## PLANNING COMMISSION MEETING

Wednesday, February 18, 2026 at 6:00 PM  
Hamburg Township Hall Board Room

- [2.](#) **PSUP 26-0001** Special Land Use - White Water Express Car Wash
- [3.](#) **PSPA 26-0001** Preliminary Site Plan - White Water Express Car Wash

**To:** Planning Commissioners  
**From:** David Rohr  
Hamburg Township  
Township Planner  
**Date:** February 18, 2026  
**Project Number:** Preliminary Site Plan Application **PSPA26-0001**

TITLE:  
**LANDSCAPING PLAN**

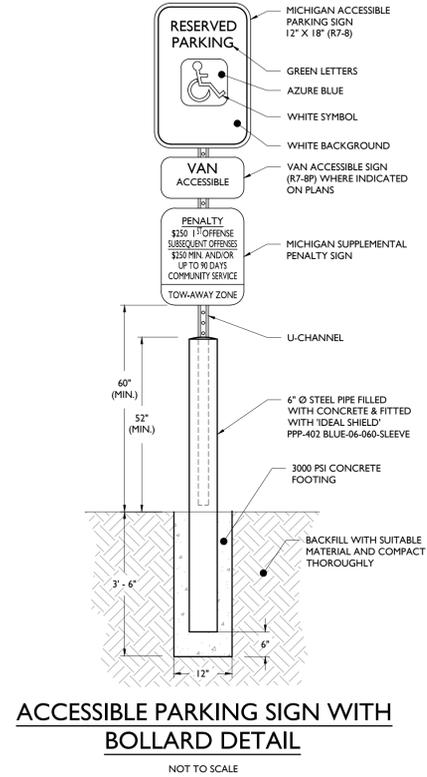
The preliminary plan provides a tree planting plan. **Page C-10** of the site plan provides detailed landscaping details for different sections of the development.

The landscaping plan as presented satisfies the landscaping requirement with one exception on the west side of the parcel. A 60ft wide utility easement on the west side precludes planting trees.

<p>Applicant should work with Township Utilities department on easement encroachment agreement.</p>	
<p><b>Lighting:</b>                  The preliminary site plan includes a lighting plan on page C-8. The lighting plan as presented seems to meet all requirements.</p>	
<p><b>Signs:</b>                  No Sign details were submitted. Proposed signage should be provided as a part of the final site plan review and shall meet the requirements of the zoning regulations.</p> <p><b>Suggested Condition 2:</b>                  A detailed sign plan should be submitted for final site plan review.</p>	
<p><b>Sidewalks/pedestrian circulation.</b></p> <ol style="list-style-type: none"> <li>1. Site design shall demonstrate a special sensitivity to pedestrian circulation and safety. ✓</li> <li>2. Sidewalks at least five feet wide and at least seven feet wide where abutting parking shall be provided along public streets and private roads; bike paths shall be required in locations designated in the Hamburg Village master plan or to provide linkages with existing or planned bikepaths. ✓</li> <li>3. All developments shall provide pedestrian linkages between public sidewalks and the building entrances. ✓</li> </ol> <p>Staff Analysis:                  The sidewalk system within the development has been designed to provide good pedestrian access within the site.</p>
